REMARKS

Drawings

AMENDMENTS TO THE DRAWINGS:

Fig. 1

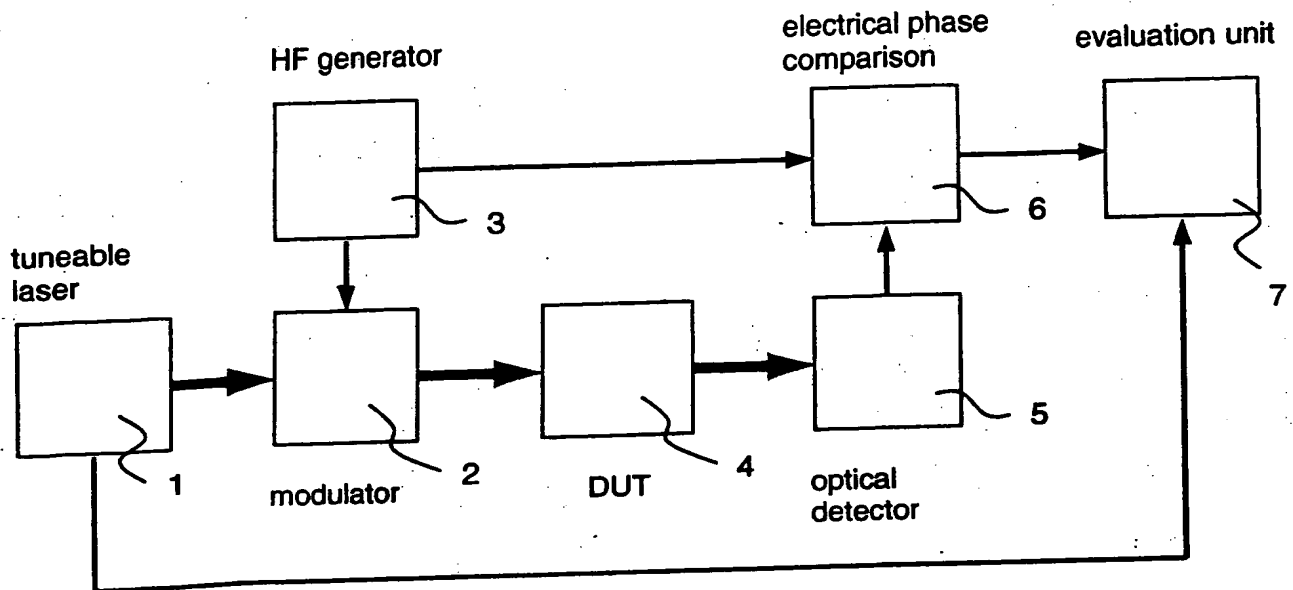
The drawings have been amended as suggested by the Examiner to identify Figures 1–3 as “Prior Art.” Replacement sheets as required by 37 C.F.R. § 1.84(c) are being filed with this response.

The attached sheets of drawings include the legend “Prior Art” in Figures 1, 2, and 3.

(Prior Art)

Fig. 3

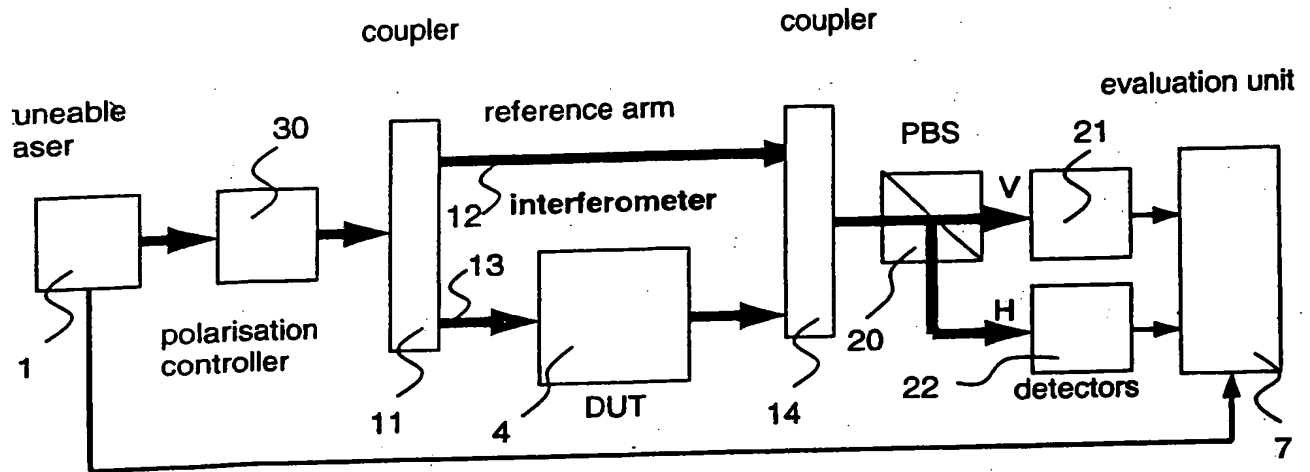
What the admitted prior art discloses is the provision of a polarization beam splitter PBS (see figure 3 of the present application, beam splitter indicated at 20). The polarization beam splitter includes two optical detectors. There is no polarimeter. The language of claim 17 indicates that two orthogonal states of polarization for determining the power changes are selected **using said polarimeter**. According to claim 17, the selection is to be made in such a manner that **power from the reference arm interferometer apparatus is broken down into virtual partial powers of approximately the same magnitude**. In other words, there is not real splitting of the beam in the reference arm. Rather, the two orthogonal states of polarization selected **at a later stage** behind the reference arm are selected in such a manner that the result is essentially the same **as if a virtual splitting in the reference arm had taken place**. That feature is explicitly described from page 5, line 23 to page 6, line 13 of the present application.

The present invention goes beyond the prior art admitted in Figure 3 of the present application because while Figure 3 relates to a real beam splitting, the present invention relates to a virtual beam splitting.

(Prior Art)
